8XC152JX

SPECIFICATION UPDATE

Release Date: July, 1996

Order Number: 272882-001

The diagrams below illustrate the areas of a DMA transfer during which the rising edge of the INTx pin will and will not cause the bug to appear. Each of the four transfer modes are shown.

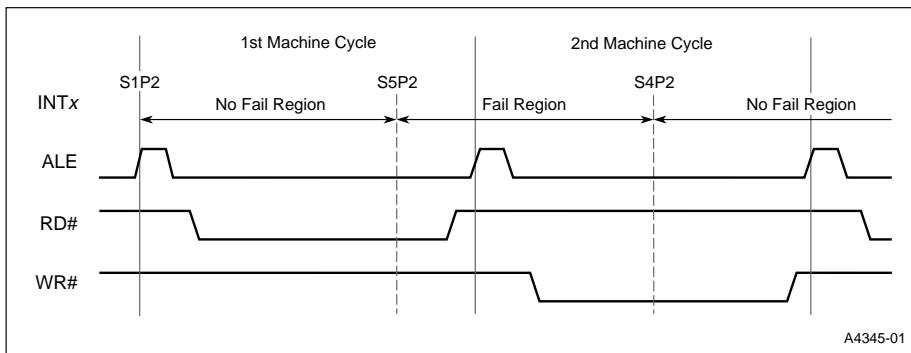
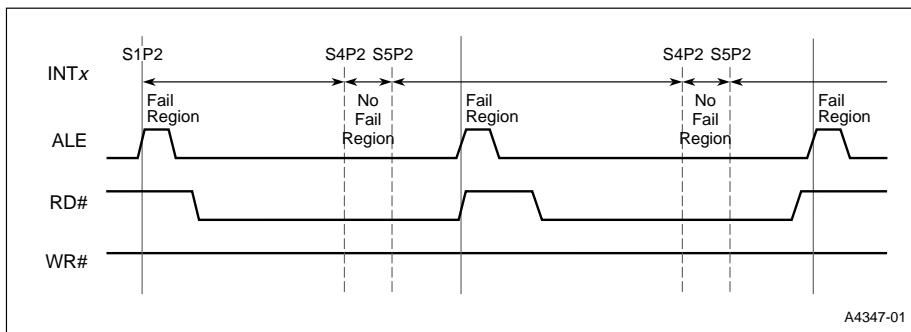
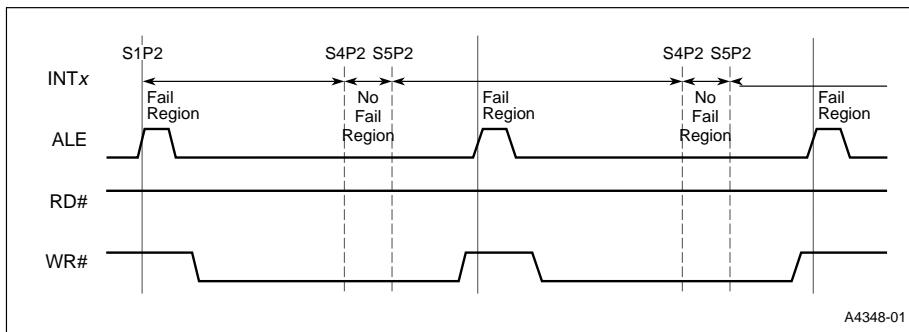
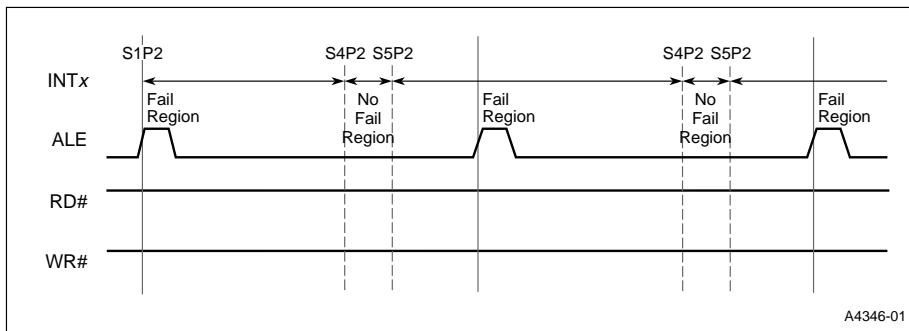
PROBLEM: On the 8XC152JA/JB/JC/JD, a failure mode occurs by using either DMA channel in level-sensitive, external demand mode. If, after a transfer begins, the INTx pin goes high between S5P2 and S4P2 of a DMA cycle, an extra DMA transfer will take place.

IMPLICATION: The condition above applies to all single-machine-cycle transfers. All DMA transfers take one machine cycle except the external-external transfer which takes two. For this mode, the bug appears only if INTx goes high between S5P2 of the first machine cycle, and S4P2 of the second.

WORKAROUND: At this point there are no known software or hardware workarounds. The following diagram gives a graphical description of the anomaly.
